Project:-  
**PETIT PAN - NEW STORE**

Title:-  
**PROPOSED SHOPFRONT  
 ELEVATION, PLAN & SECTIONS**

Scale	DWG No.	Drawn	Checked
1/20	8270-03	OS	BIL

Date	AutoCAD File Ref	Revision
28-02-17		C

SHOPFRONT ELEVATION

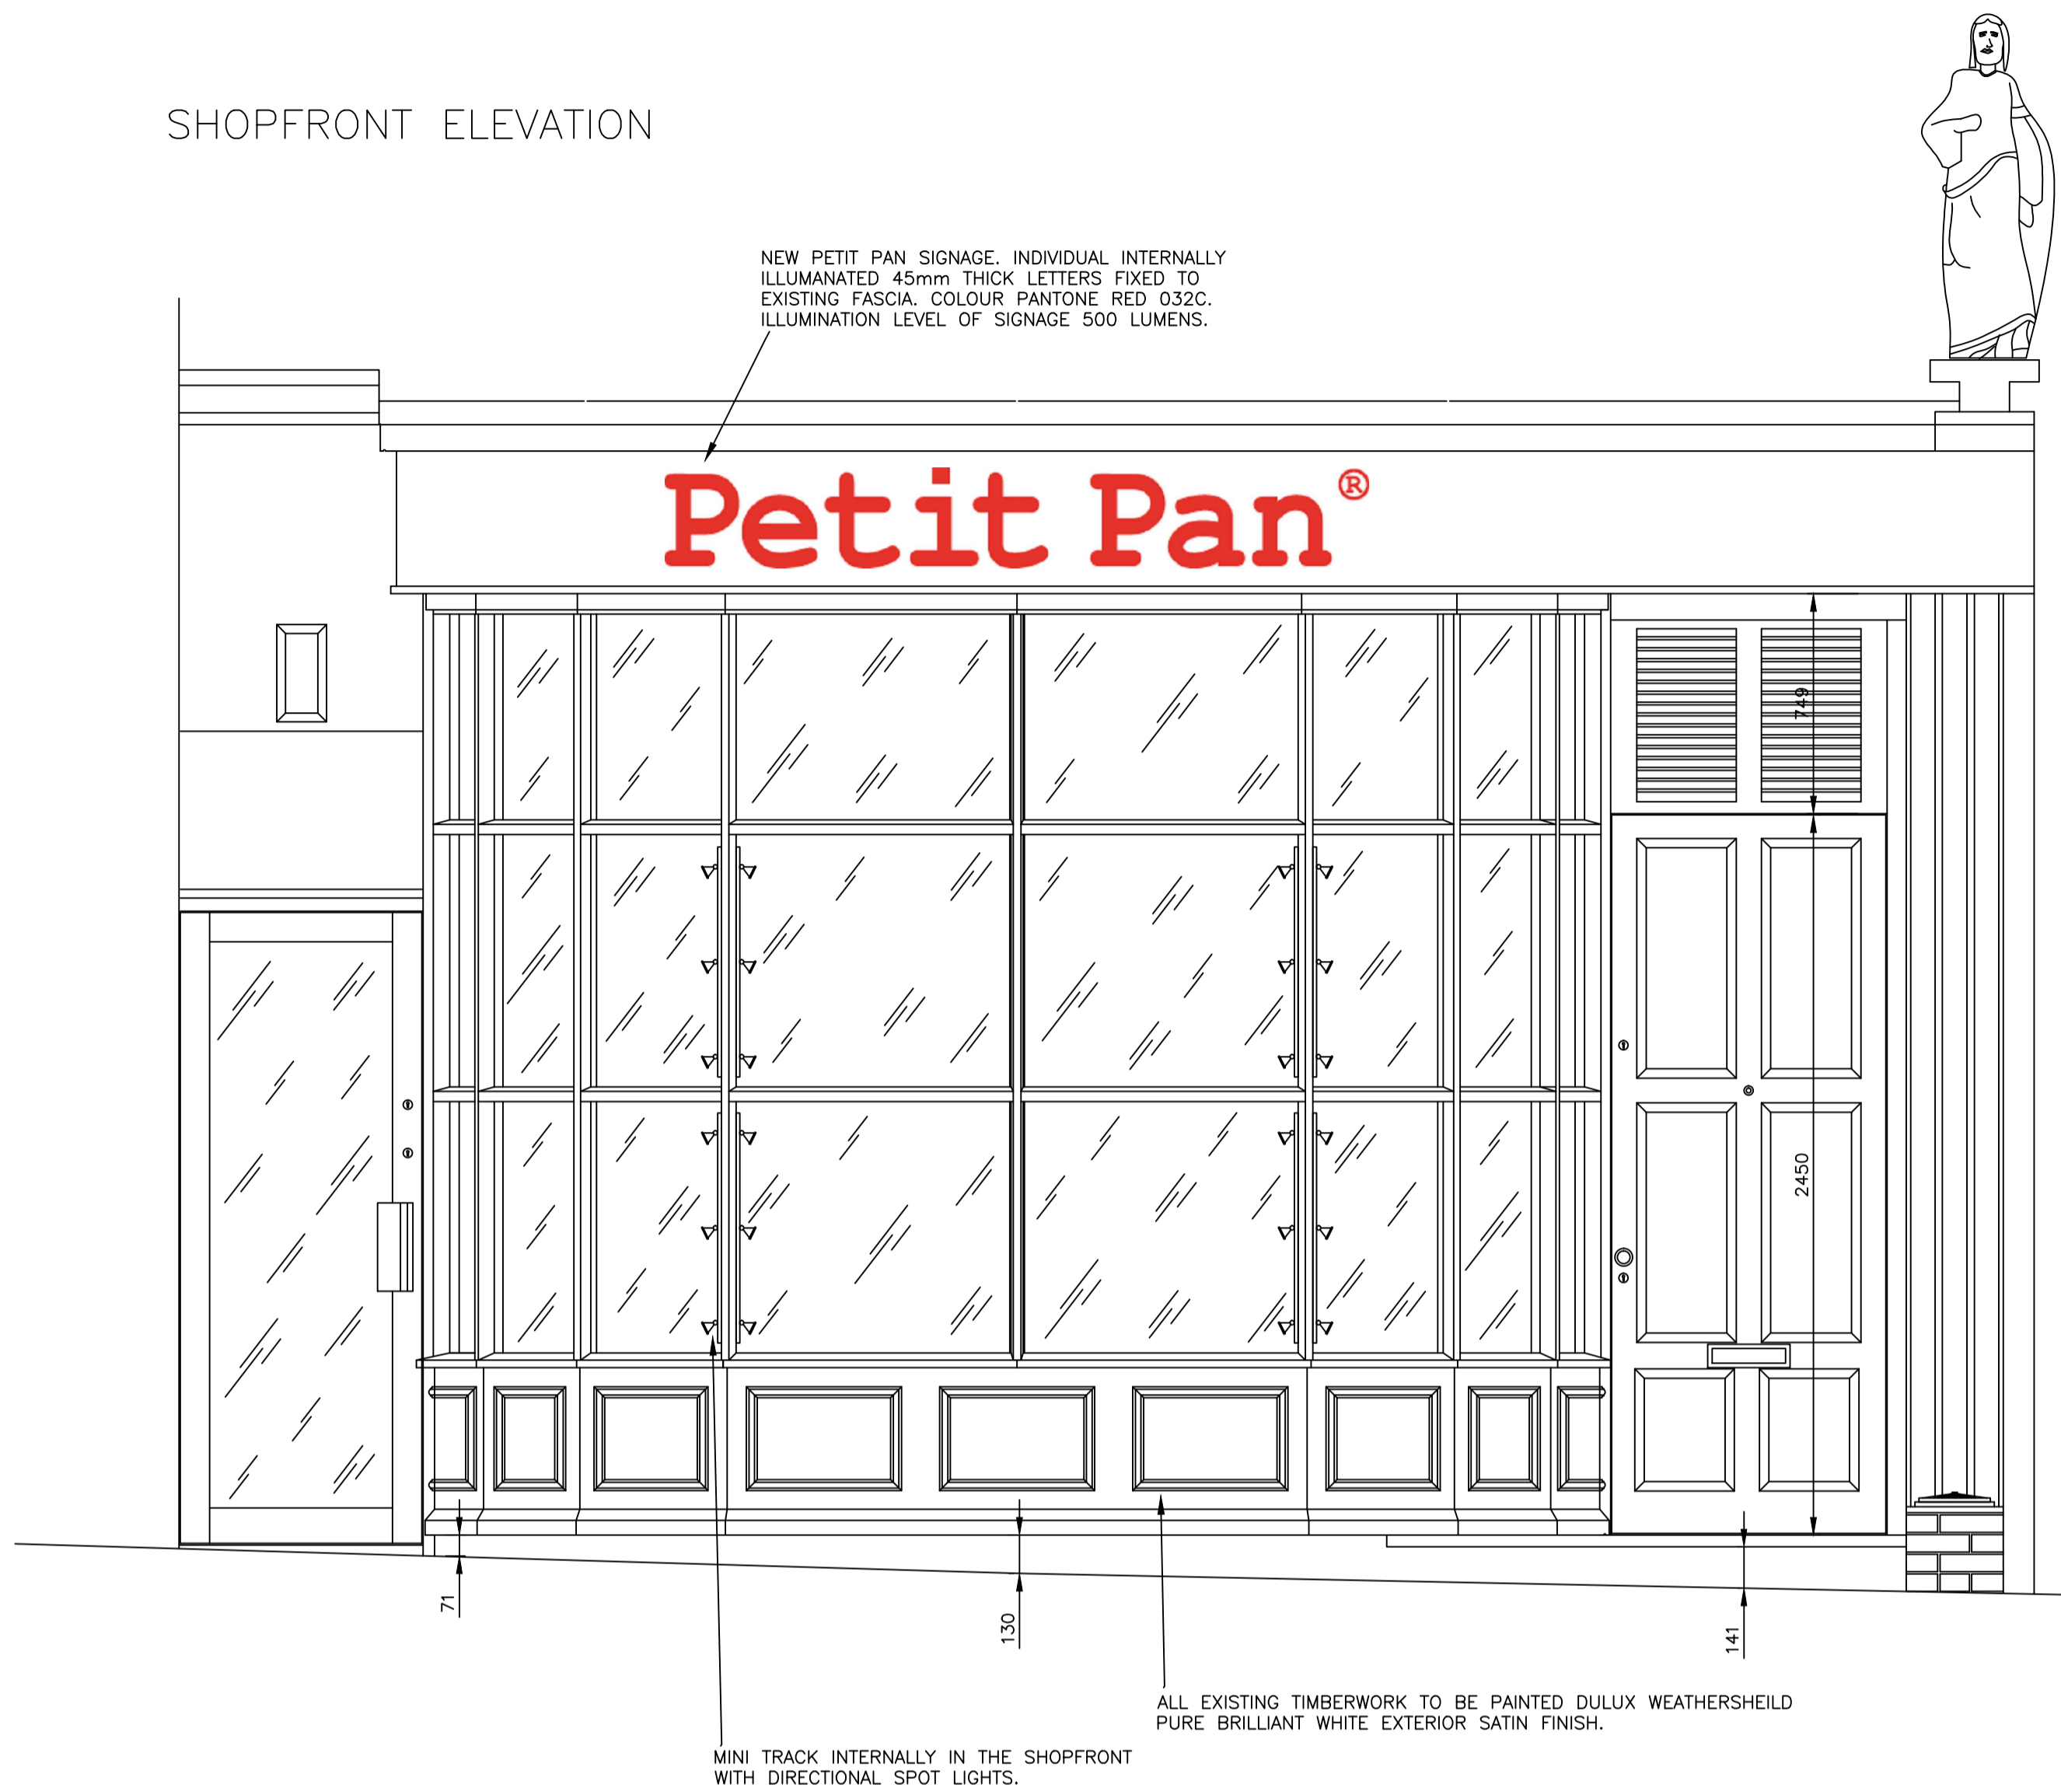
Revision	Description	Date	30-03-17
C	REVISED SIGNAGE AS REQUESTED BY CAMDEN COUNCIL. LETTERS REDUCED IN THICKNESS TO 45mm DEPTH OF FASCIA.		OS
B	REVISED SIGNAGE AS REQUESTED BY CAMDEN COUNCIL. HIGH LEVEL LIGHTING REMOVED & ILLUMINATION TO SIGNAGE LETTERS ONLY.	20-03-17	OS
A	REVISED AS CLIENTS COMMENTS ON ON MARKED UP DRAWINGS FROM SITE MEETING - 02-03-17	08-03-17	OS
